ENGINE - FUEL AND CONTROL - TO PROVIDE A NEW ELECTRONIC ENGINE CONTROL (EEC) WITH THE  
SCN11H SOFTWARE CONFIGURATION - CATEGORY CODE 8 - MOD.ENG-73-0032

V2500-ENG-73-0032

## **ENGINE FUEL AND CONTROL - EEC150-1 ELECTRONIC ENGINE CONTROL - INCORPORATION OF NEW SOFTWARE CONFIGURATION**

Location of ACC Front Duct Cover Assembly  
Fig.2

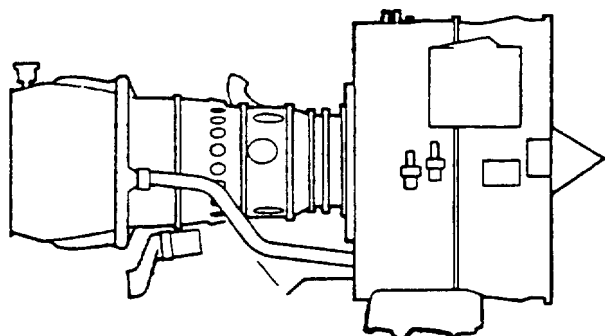
- (2) Remove the Active Clearance Control (ACC) Front Duct Cover Assembly. Remove to Reference (1) and Figure 2.

(b) Remove the two 4W0102 Bolts from the Front Duct Cover Assembly.

(c) Remove the 2A3637 Front Duct Cover Assembly.

NOTE: When you incorporate this Service Bulletin with the new SCN11H software logic, the Front Duct Cover Assembly given in Reference (1) must be removed.

Location of Electronic Engine Control (EEC)  
Fig.1

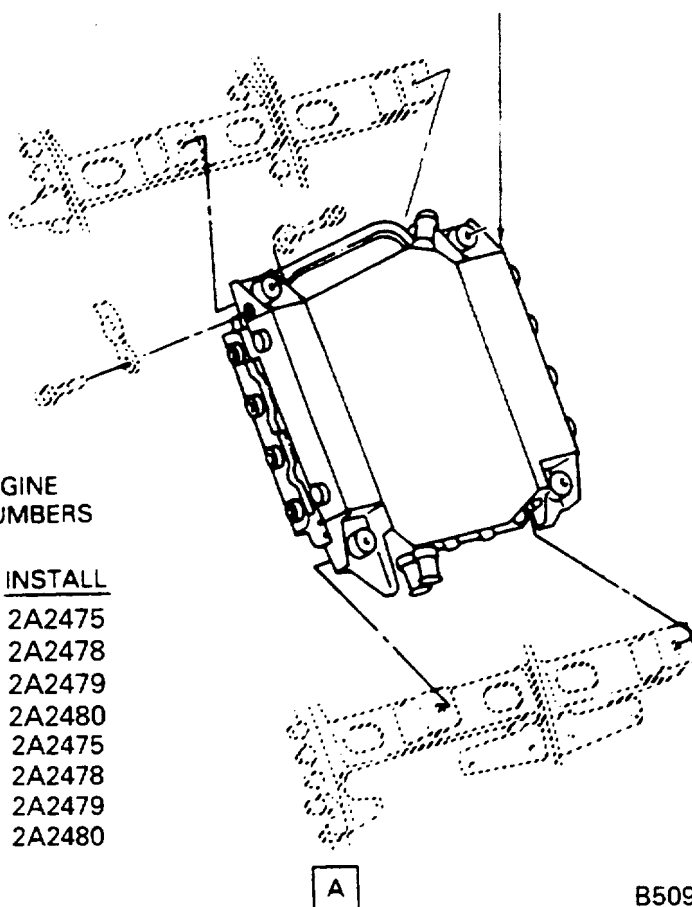
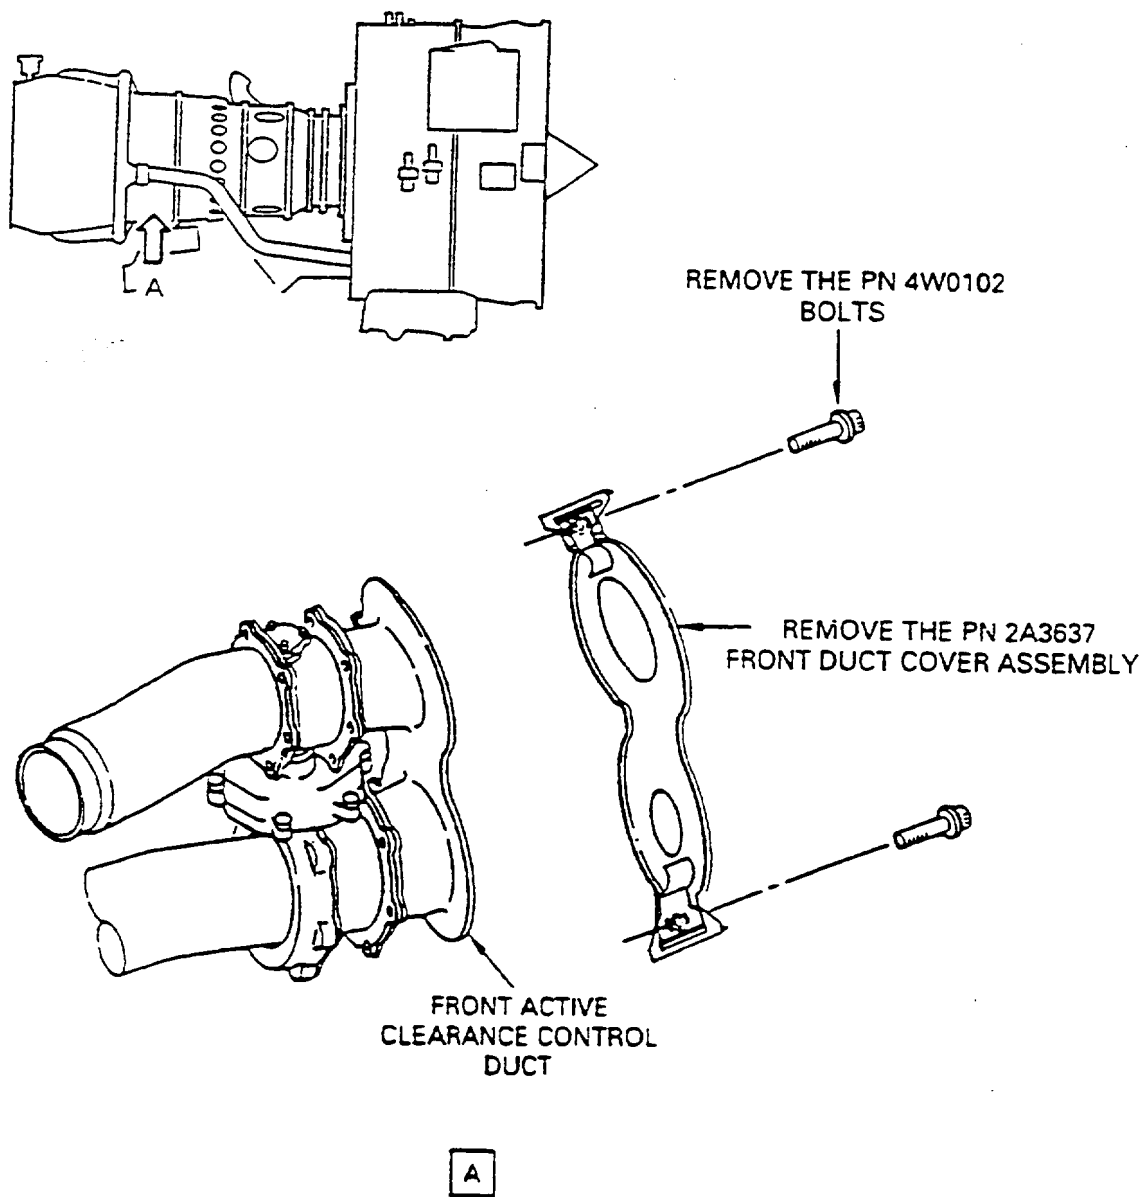
- (1) Do a modification of the 2A2166, 2A2189, 2A2284, 2A2285, 2A2356, 2A2390, 2A2391 or 2A2392 Electronic Engine Control (See Reference (4), Chapter/Section 73-22-34, Fig/Item No.01-280) and reidentify by the procedures given in Reference (3).

Procedure	Supplemental Information
(a) Send the Electronic Engine Control to the approved vendor to be modified.	See Figure 1.

REMOVE THE APPLICABLE PART NUMBER\*  
ELECTRONIC ENGINE CONTROL, DO A  
MODIFICATION, IDENTIFY AND INSTALL  
THE APPLICABLE PART NUMBER\*  
(1 Off)

- (1) Install the 2A2475, 2A2478, 2A2479, or 2A2480 Electronic Engine Control (1 off) by the approved procedure given in Reference (5), Chapter/Section 70-00-32, Installation-02. See Figure 1.

Family Tree - Electronic Engine Control (EEC)  
Fig.3 (Sheet 2)

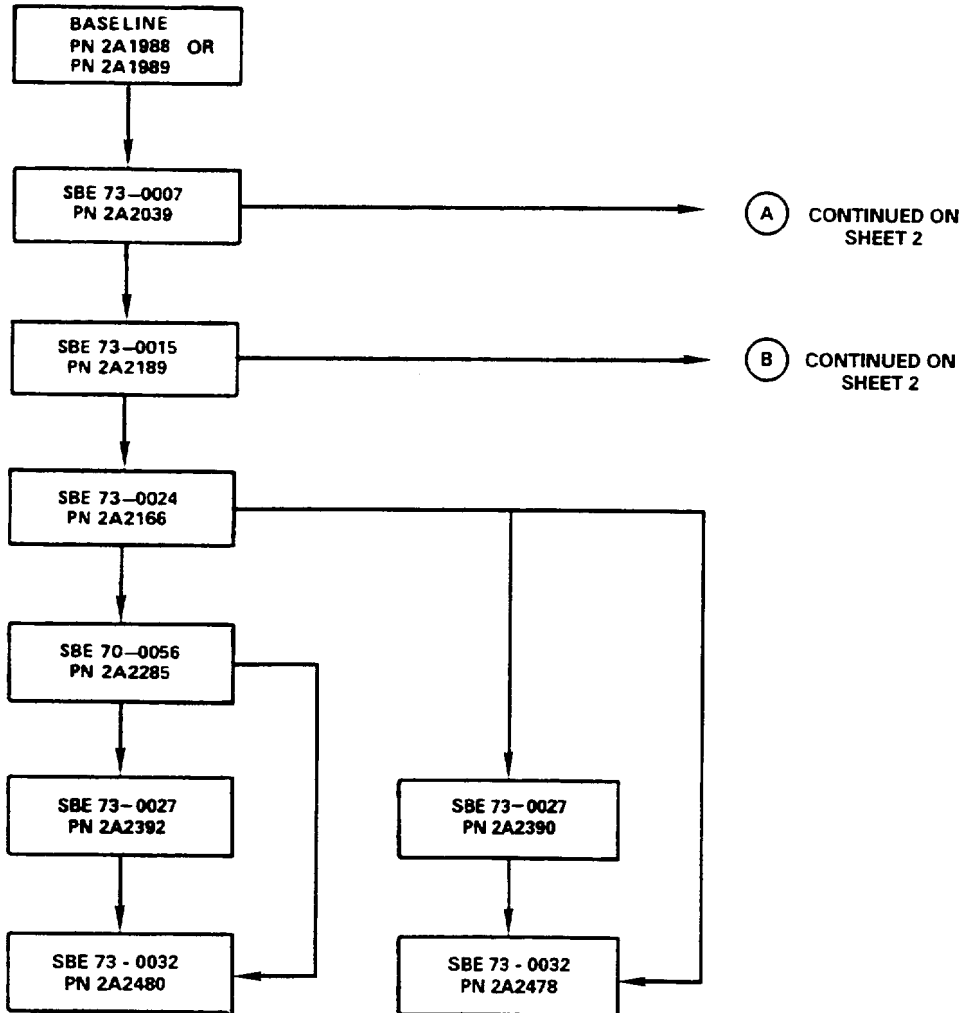
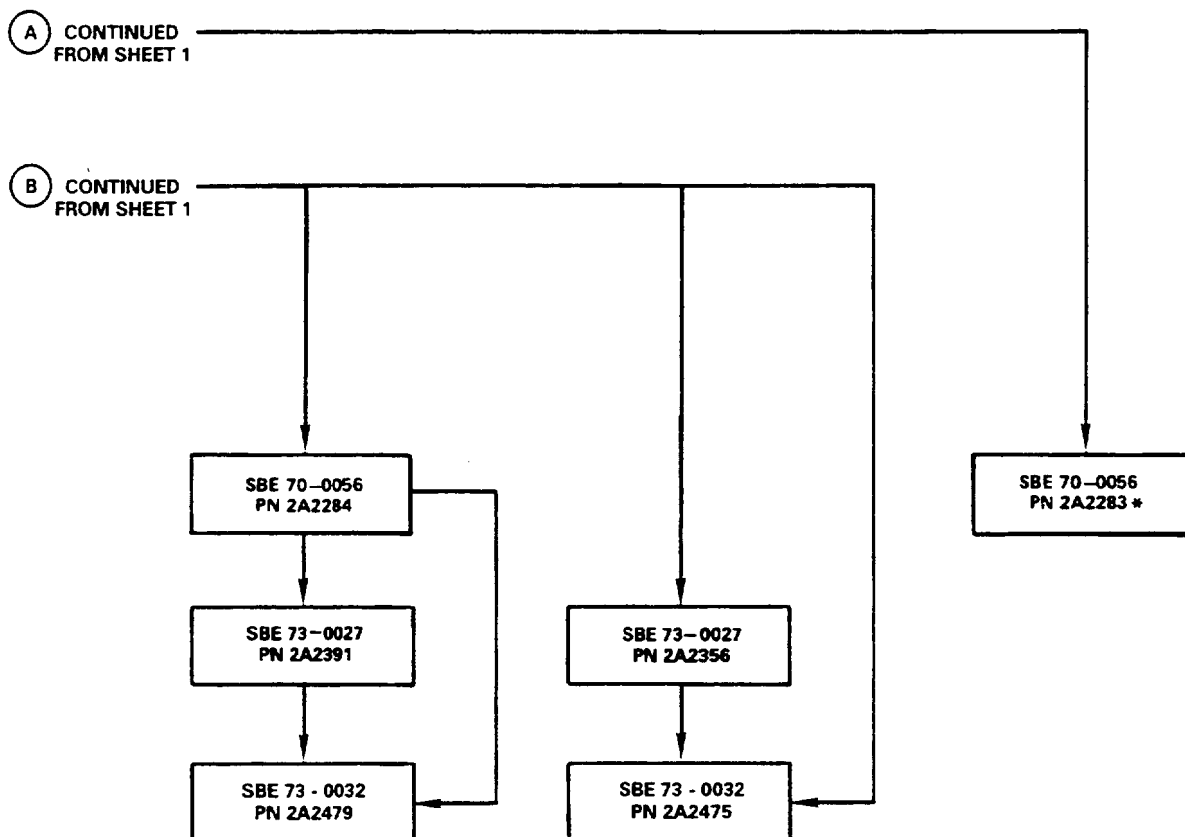
\* Incorporation of the latest software configuration, given in V2500-ENG-73-0032, will include all the software improvements which were made in V2500-ENG-73-0027. This is why there is more than one old part number progressing up to the same new part number.

• THERE IS NO PROCEDURE TO  
ADVANCE THIS CONFIGURATION
